From: Paul Mood
Sent: Friday, November 16, 2018 9:04 AM
To: Brian Dalke; Jeremy Knapp
Cc: Dawn Marie Buckland; Paul Michaud; Paul Mood
Subject: Lincoln Drive Median Access
Attachments: Lincoln Median Access - Engineering Dept. Review.pdf; ATT00001.htm; Lincoln Median Access Kimley Horn 3rd Party Review.pdf; ATT00002.htm

RE: Lincoln Drive Median Access from Mockingbird Lane to the Eastern Town Limits

MEMORANDUM

Subject: Lincoln Drive, Mockingbird Lane to Town of Paradise Valley (TOPV) Jurisdiction
Median Breaks and Access
Third Party Traffic Review Comments

Figure 4.2 Process for Selecting Average Rate or Equation in Trip Generation Manual Data

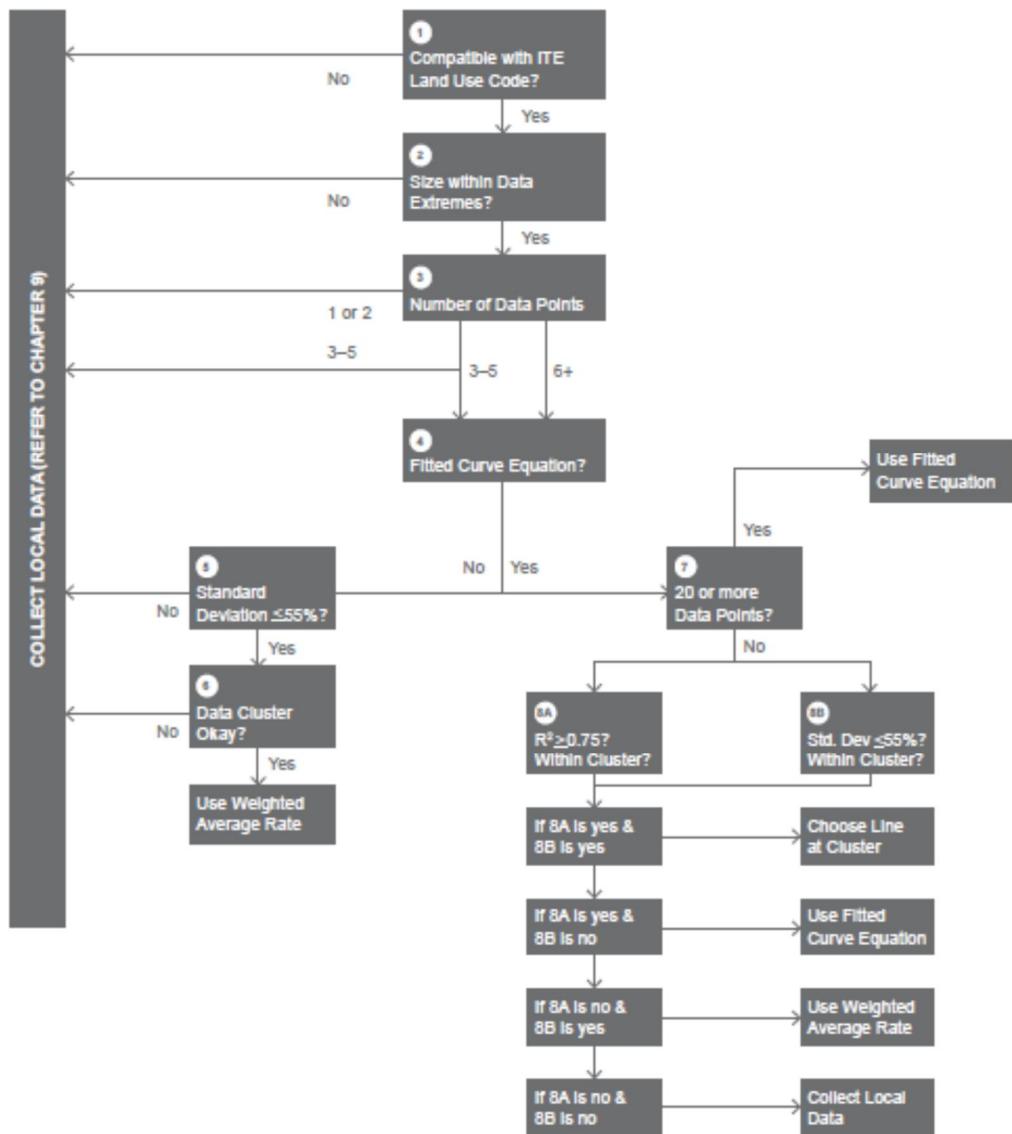
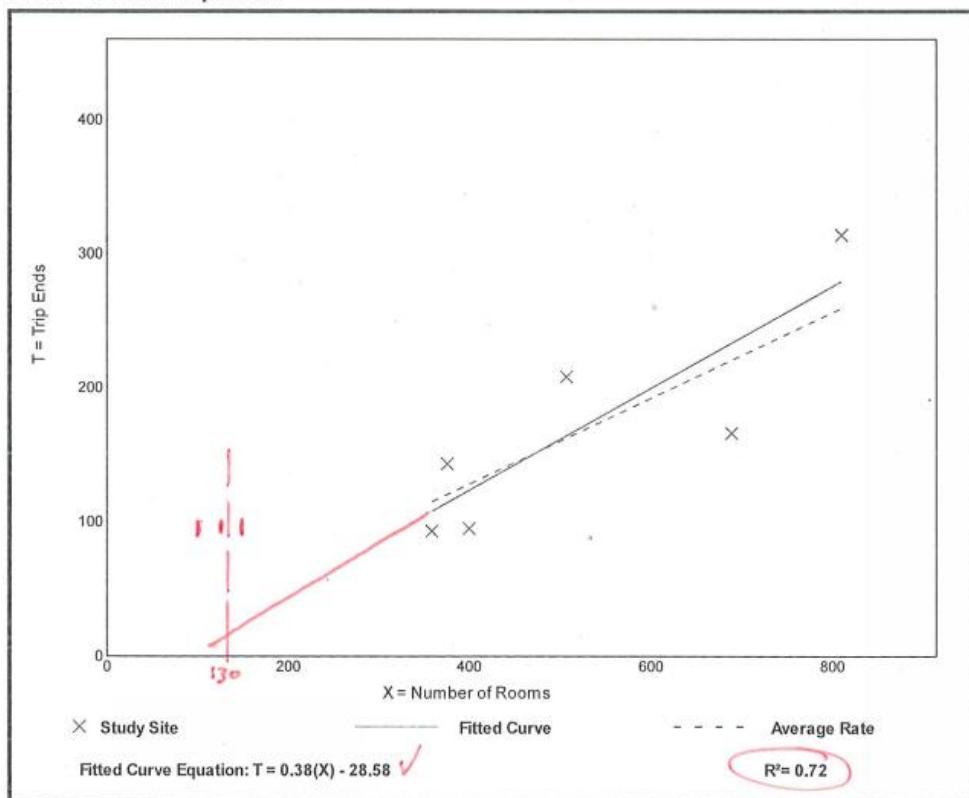
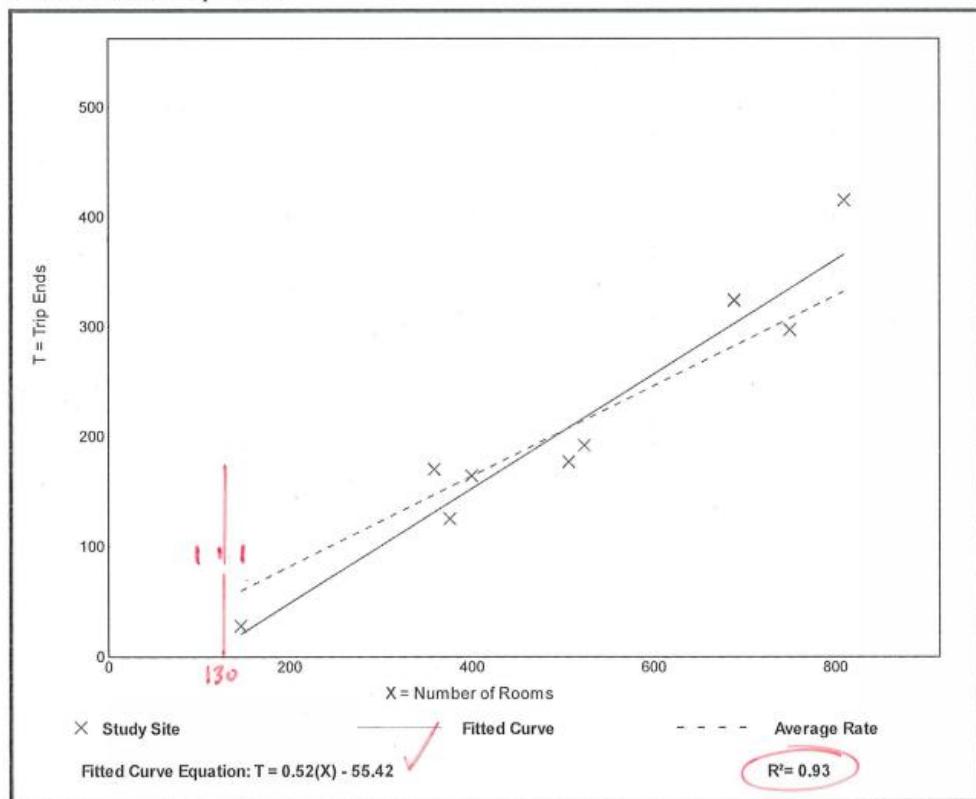
KH Comments 4: Smoke Tree Resort utilized equations as opposed to average rates. KHA went through the ITE Trip Generation Handbook process presented in Figure 4.2 assuming proposed number of units for resort hotel (LUC 330). The results of this process are presented below and KH redlines provided in **Appendix 1**.

- The number of rooms is way out of range of the data extremes; the lowest number of rooms in the manual is roughly 370 compared to the 132 that are proposed
- If you follow the equation, which happens to be a straight line and not a logarithmic function, then 132 rooms will generate a very low number of trips
- The number of data points is equal to 6
- The R2 value is close to the required 0.75, so you could argue it either way
- The standard deviation is less than 55% of the average rate

Because the rooms are not within the data extremes and the R2 value is less than 0.75, we recommend the weighted rates be used. Using the rates as opposed to the equation results in double the trips being generated in the AM peak hour.

- The number of rooms is just outside of the data extremes
- The number of data points is greater than 6
- The R2 value is well above the required 0.75
- The standard deviation is less than 55% of the average rate

Because the number of data points and the R2 value are high enough and the standard deviation requirement is met, the use of the equation during the PM peak is appropriate.

Response to Comment 4: CivTech has updated the trip generation rates to reflect a blended rate between LUC 310 and 330 as discussed in response to comment #3. The trip generation calculations were also revised to reflect 150 rooms, 30 residential units, and 3500 square foot quality restaurant. The revised trip generation calculations and approach were considered acceptable. The revised trip generation calculations, based on 150 rooms, 30 residential units, and 3500 square foot quality restaurant, are provided in **Appendix 2**.
